SEWAGE DISPOSAL SYSTEM

MARYLAND STATE DEPARTMENT OF HEALTH

HOWARD COUNTY

PROPERTY OWNER Jesse Hakes

INDICATE NORTH. - NAME ADJOINING ROADWAY AS BASE LINE.

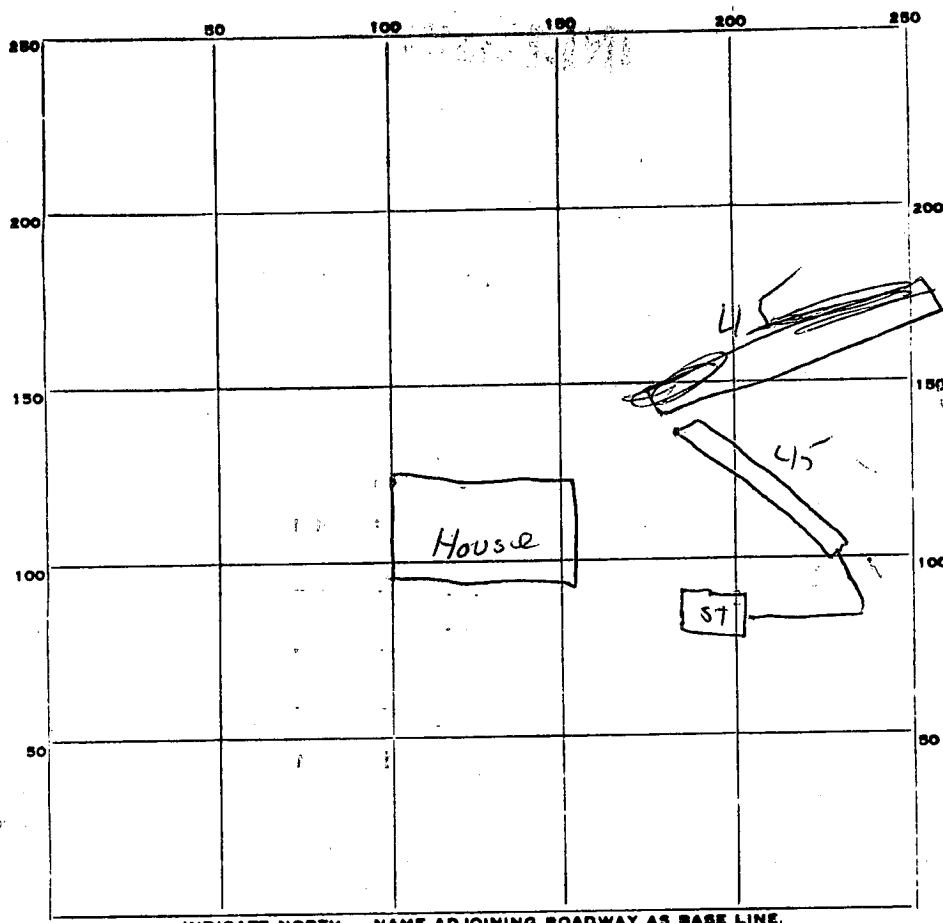
OTHER REPAIR - Call for inspection when ground is opened up and Sanitarian will recommend repair sytem. 5-4-71. trench 40 ft long - 11 ft deep - 5 ft gravel

REMARKS 5-4-71 - OK to put gravel in trench area.

TILE FIELD, DEPTH 11 FT. TRENCH WIDTH 2 FT.

GRAVEL DEPTH 72 IN. TOTAL LENGTH 45 FT.

NUMBER OF TRENCHES 1 TOTAL BOTTOM AREA 90

ABSORBENT AREA 540 SQ. FT.
